Re: Drainage Letter for Bunting MultiFamily Filing No. 1
Project No. 61072

Bunting Multifamily
Filing No. 1
Drainage Exhibit
January 1, 2012
61072-Drain-Map

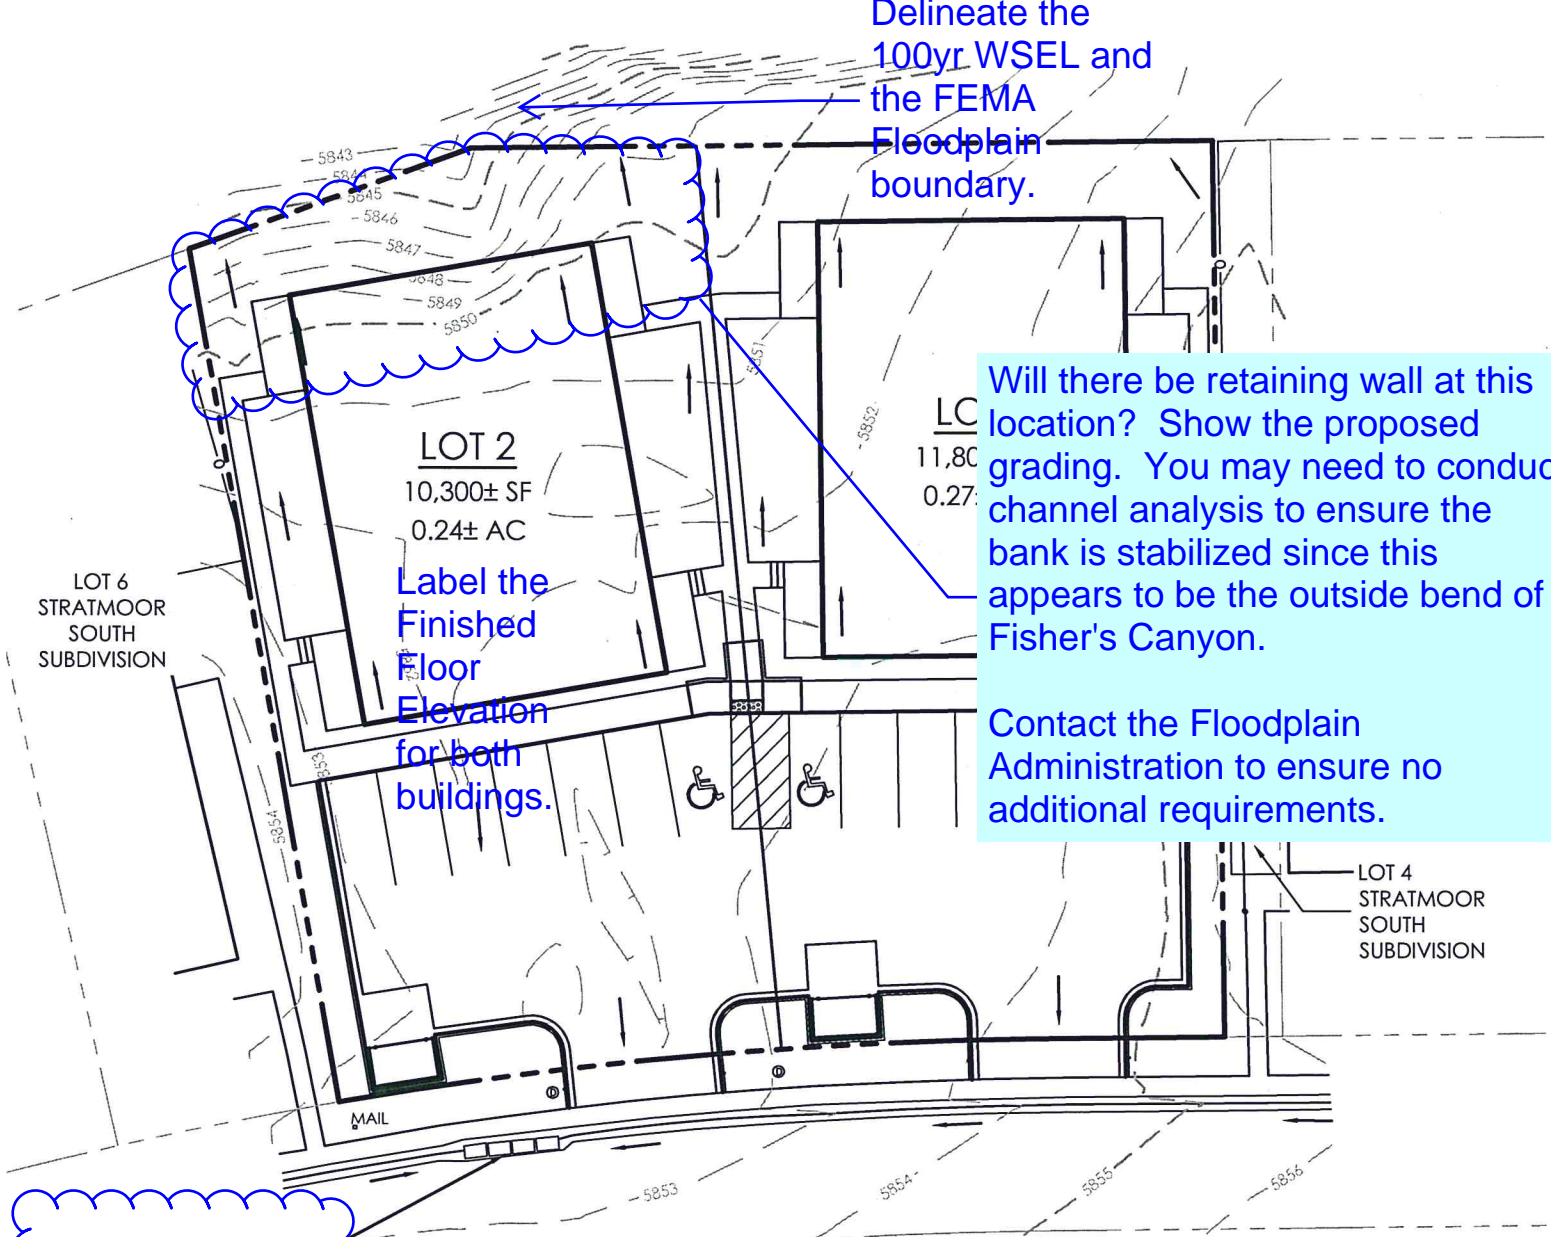
Delineate the 100yr WSEL and the FEMA Floodplain boundary.

Will there be retaining wall at this location? Show the proposed grading. You may need to conduct channel analysis to ensure the bank is stabilized since this appears to be the outside bend of Fisher's Canyon.

Contact the Floodplain Administration to ensure no additional requirements.

Label the Finished Floor Elevation for both buildings.
